**ARCHITECTURAL REVIEW BOARD
MUNICIPAL PLANNING COMMISSION
-AGENDA-
Thursday, July 13, 2023 at 7:00 P.M.**

MEMORANDUM

SUBJECT: Staff Memo for the Meeting of July 13, 2023

DRAWING NO. ARB 0048-2023

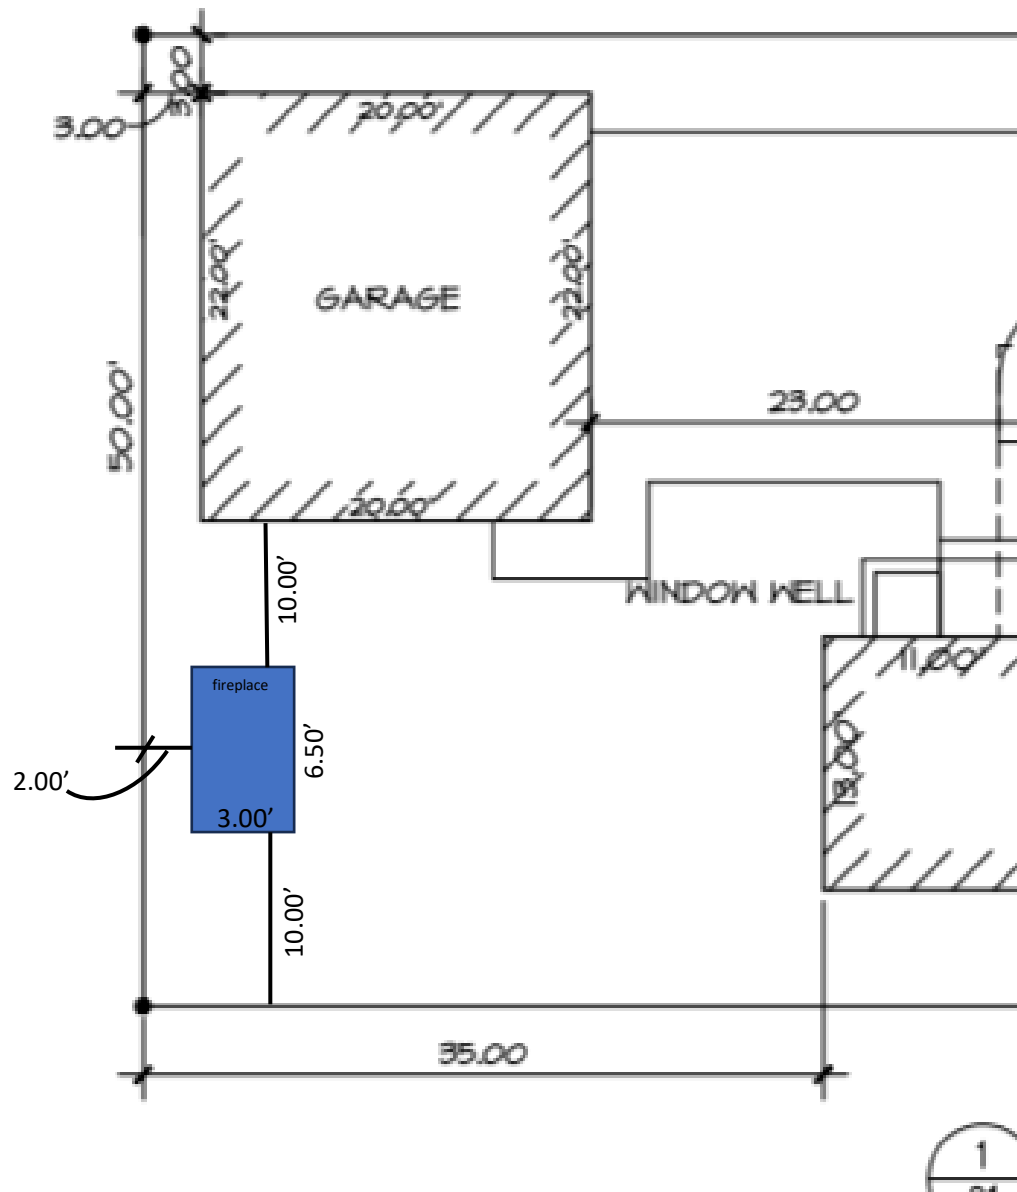
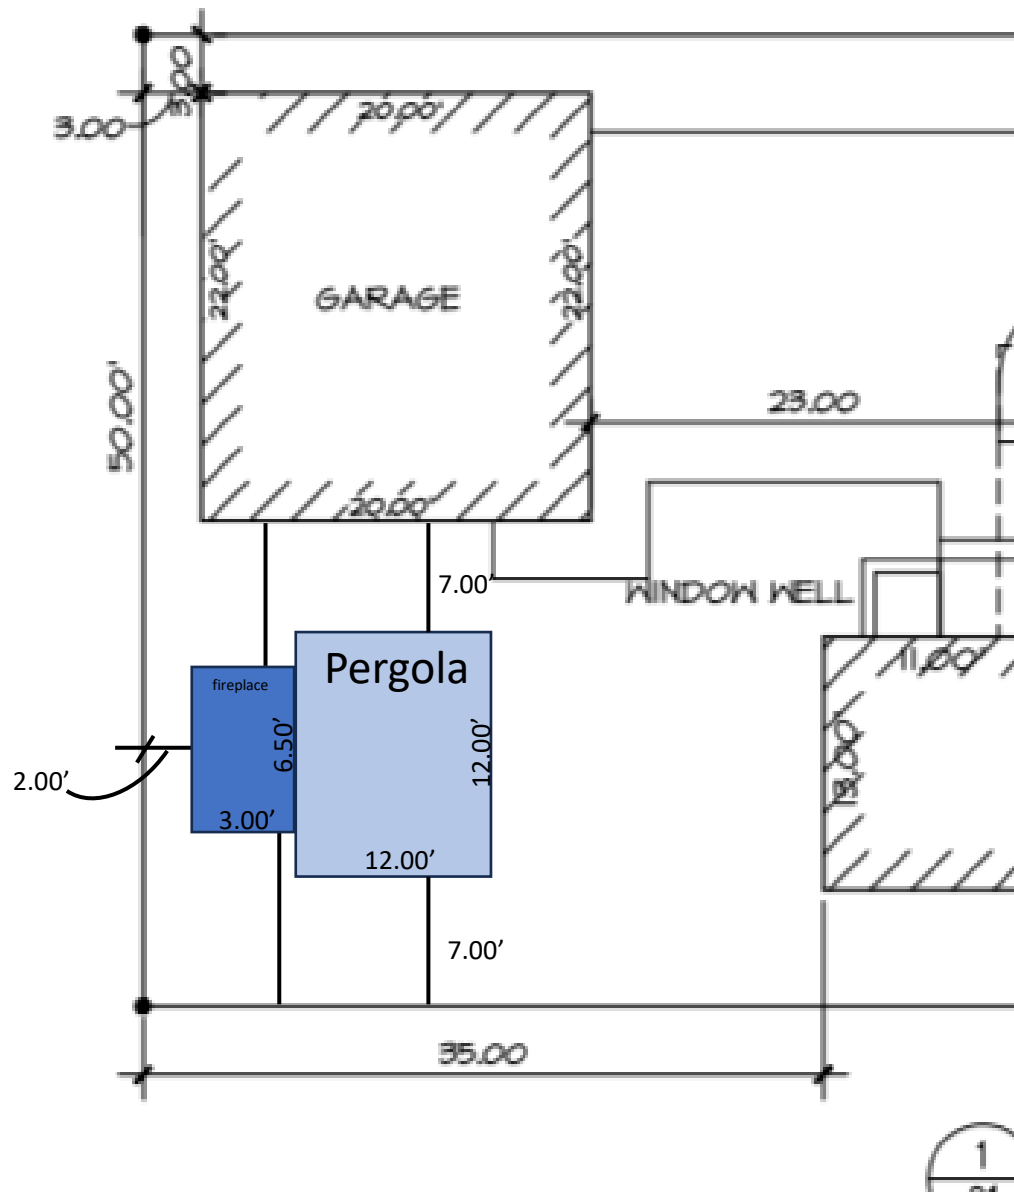
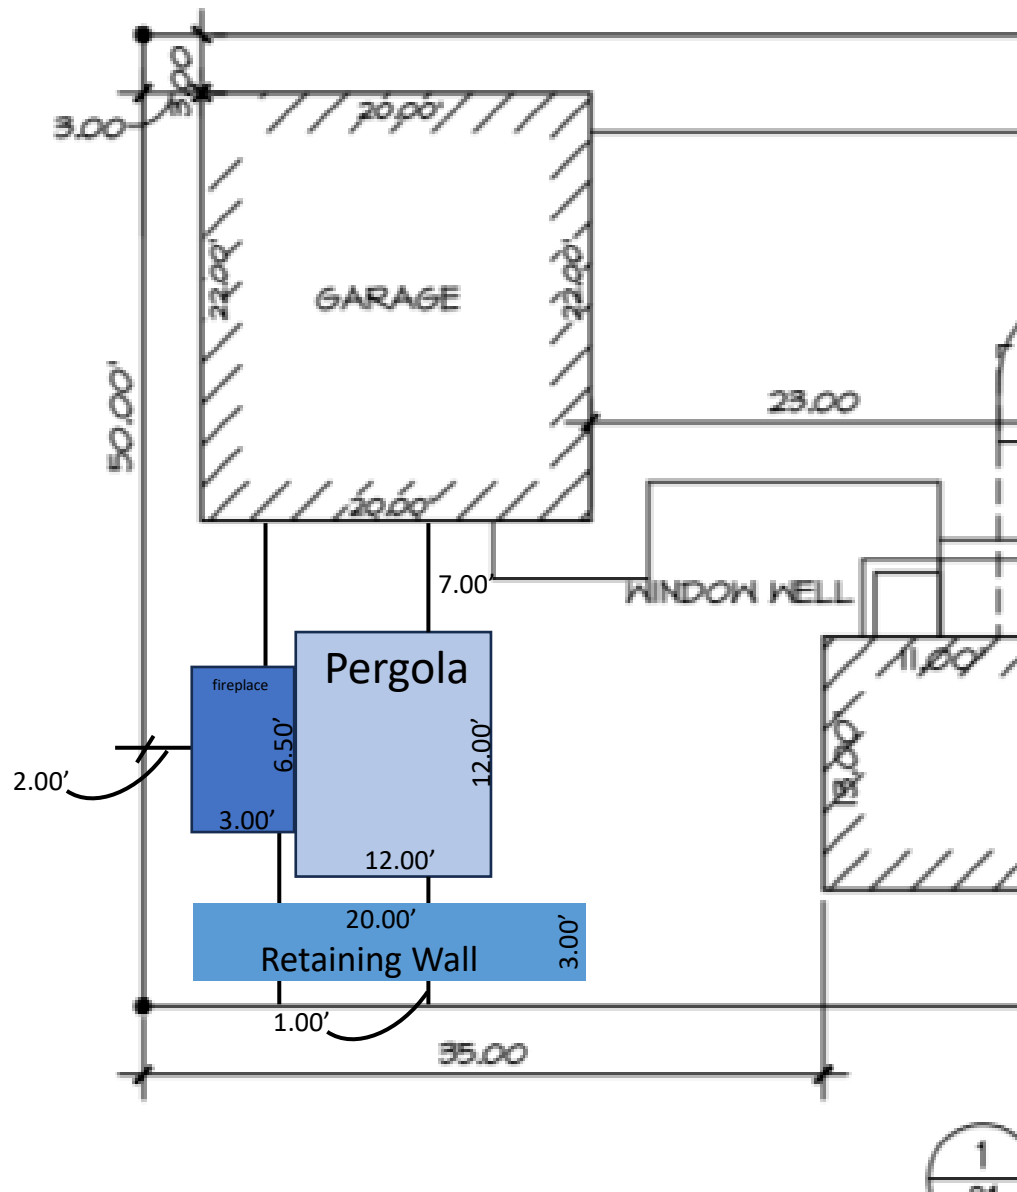
4. Variances would be needed for the fireplace and pergola being too close to the property lines.
5. The impact on storm water has not been identified.
6. A tree was supposed to be planted in the rear yard when the house was approved. If it was planted, removal would be necessary with this plan.

Although the structures proposed for this property are typical of others in the District, this lot is smaller than most. The fireplace may be too close to the rear property line. It is not clear if the retaining wall would impede storm water or accommodate an existing change in grade.

- The fireplace may not be appropriate in the proposed location.
- The retaining wall should be shown to not cause problems with storm water.

THAT THE REQUEST BY JACOB LAUGHREY FOR A CERTIFICATE OF APPROPRIATENESS TO ADD A PATIO WITH RETAINING WALL, A PERGOLA AND A FIREPLACE AT 53 SHORT ST. AS PER CASE NO. ARB 48-2023, DRAWINGS NO. ARB 48-2023, DATED JUNE 20, 2023, BE APPROVED BASED ON THE FINDINGS OF FACT AND CONCLUSIONS IN THE STAFF MEMO AND PRESENTED AT THE MEETING CONDITIONED ON SETBACK VARIANCES BEING APPROVED BY THE BZA.
